**ROANOKE CITY
PUBLIC SCHOOLS**

**IFB 3105
HURT PARK ELEMENTARY SCHOOL SECURITY UPGRADES**

Addendum #1

This addendum provides answers to questions received from contractors as of February 26, 2023, and includes revised plan sheets A041, A101, & E101 (attached).

DOOR ELEVATION TYPES SCALE: 1/4" = 1'-0"

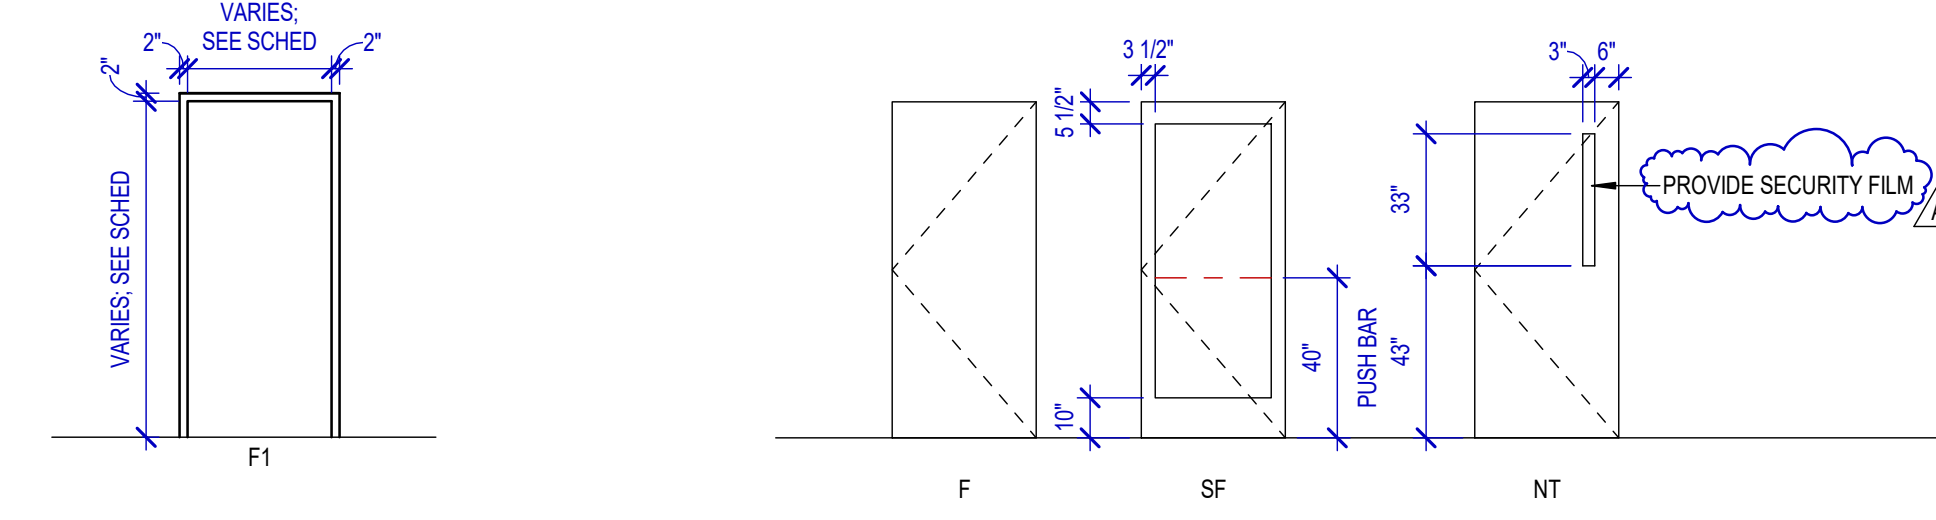
Q4 - Can we confirm that the new door to the Assistant Principal Office has no security film installed?

A4 - Please provide security film for the narrow lite in the door, see updated keynote G2 & door type elevation NT on sheet A101. Additionally, film is to be required at the existing hollow metal window. See keynote A7 on sheet A101.

1 FLOOR PLAN A101 SCALE: 1/4" = 1'-0" REF: A101

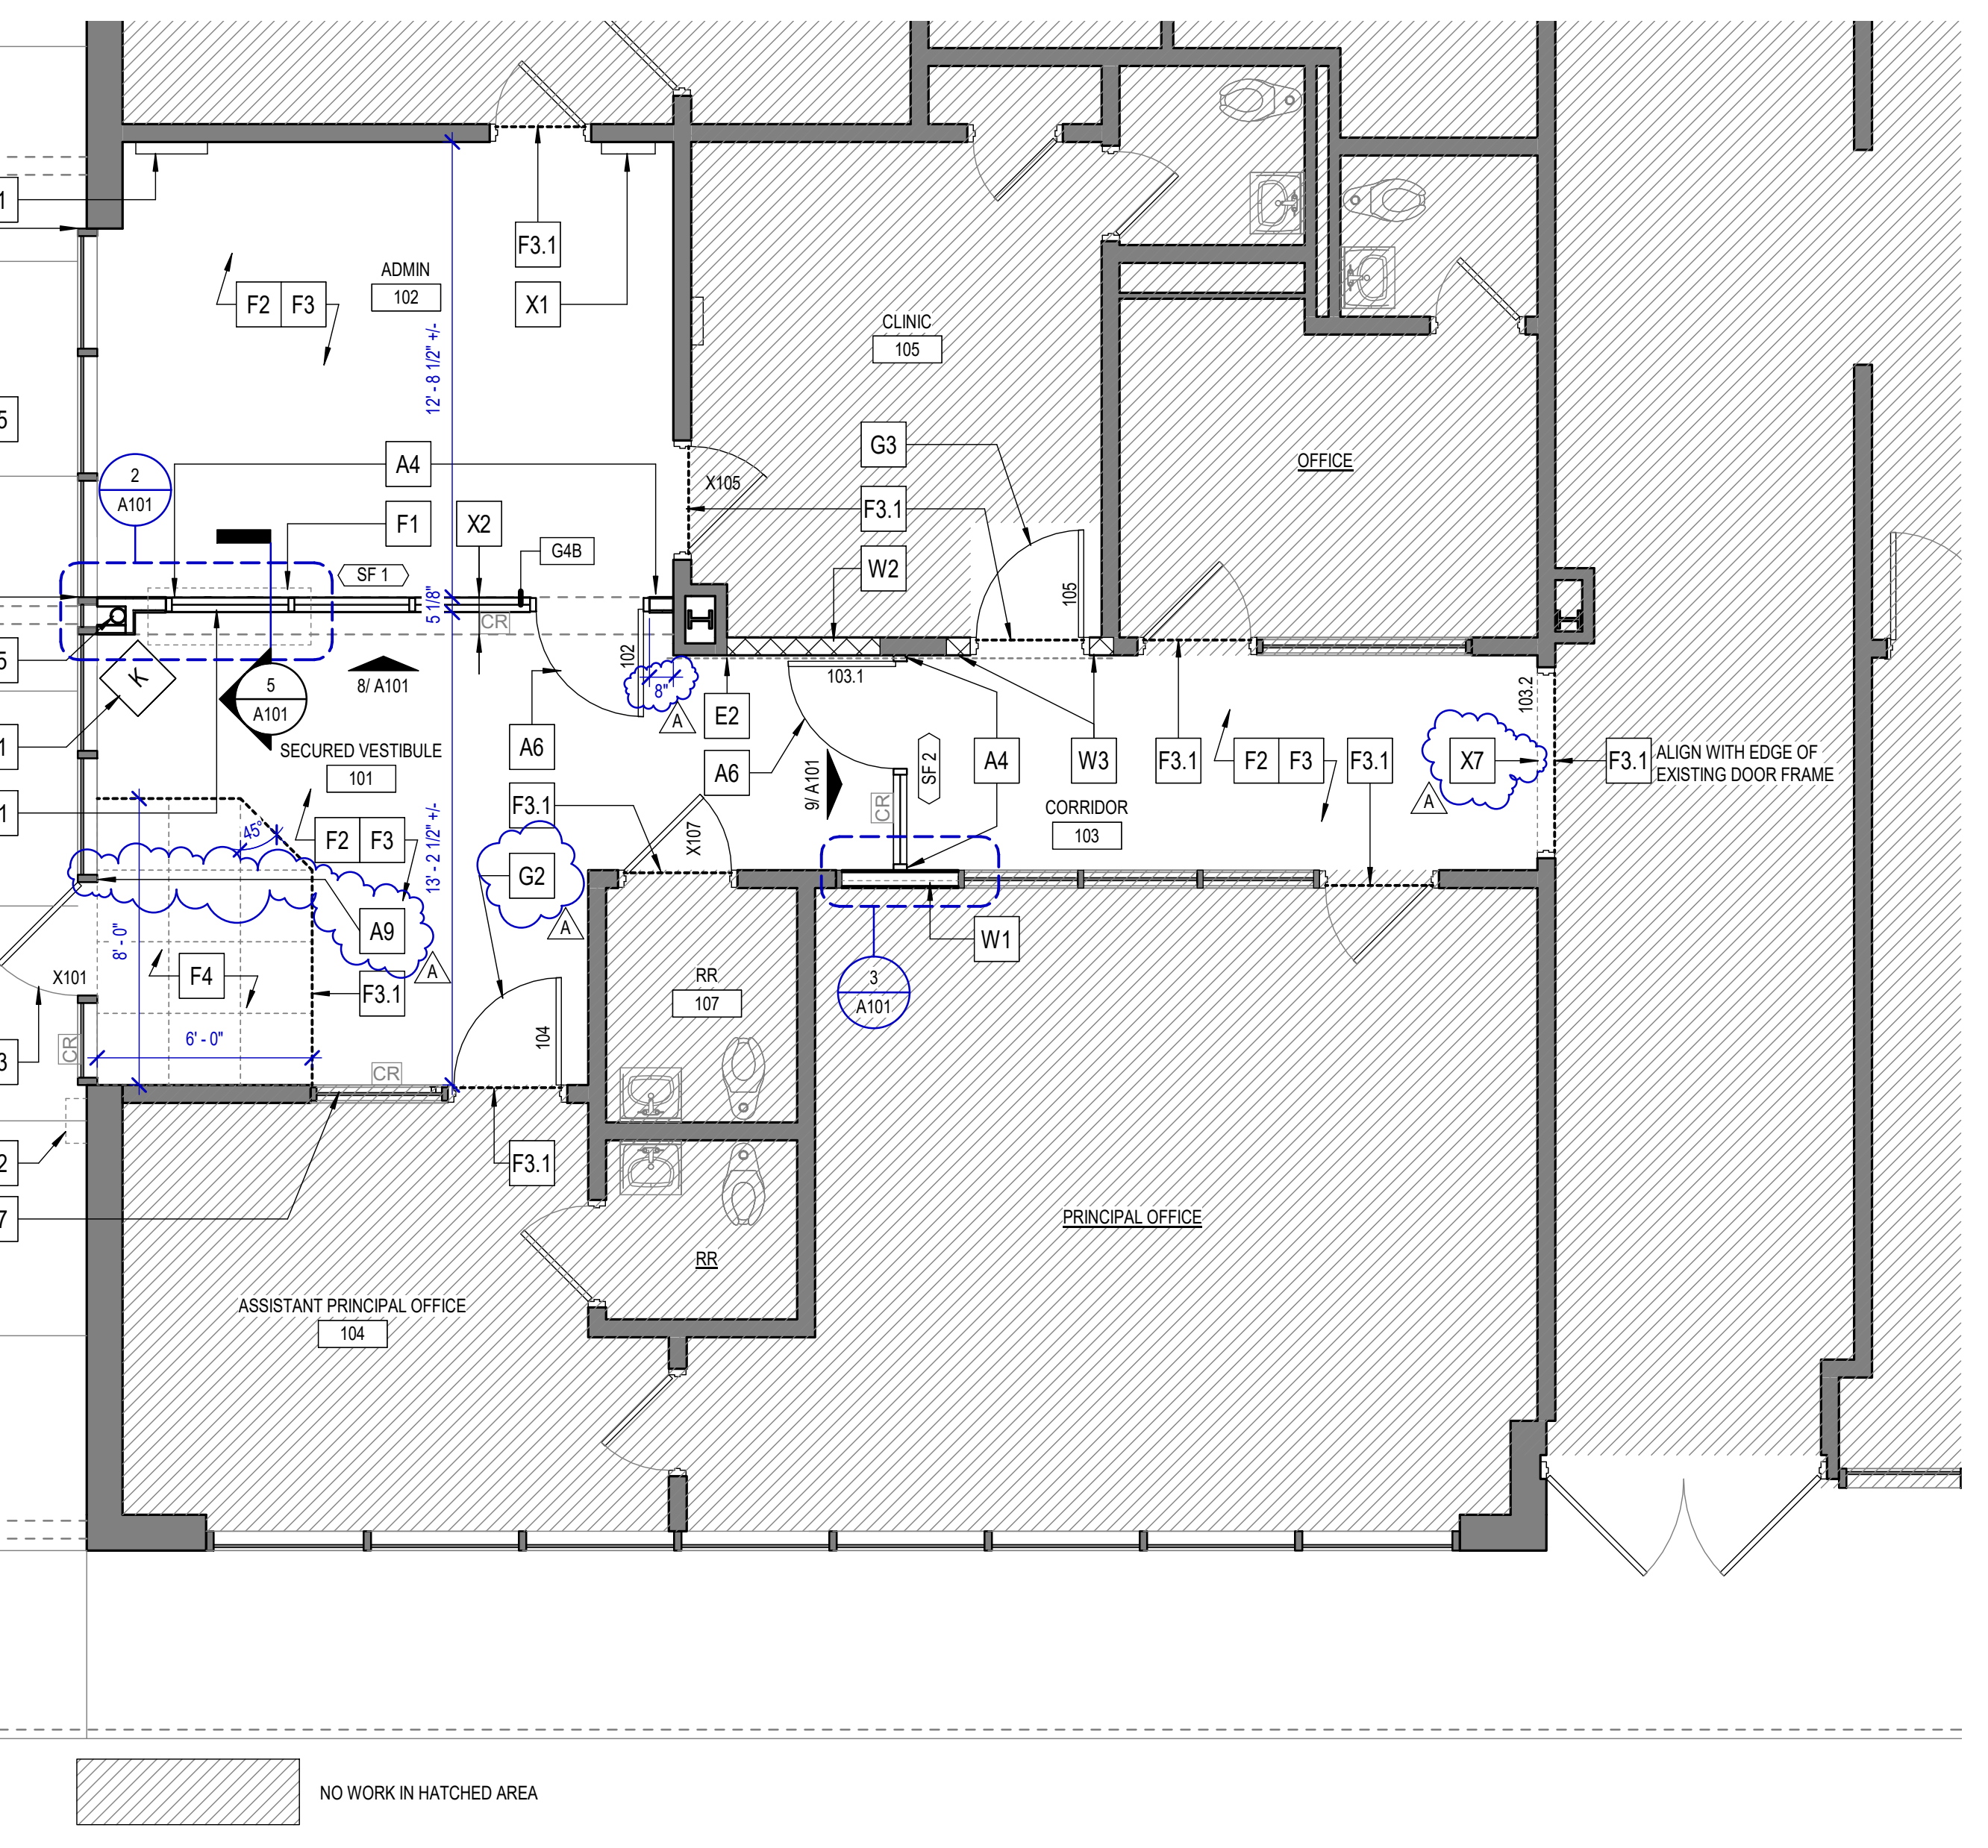
Q3 - Can we confirm that the windows on the exterior of the building in the vestibule area will not require the security film to be installed?

A3 - Security film at the existing exterior storefront is only to be provided at Admin 102. See keynote A5 on 1/A101.
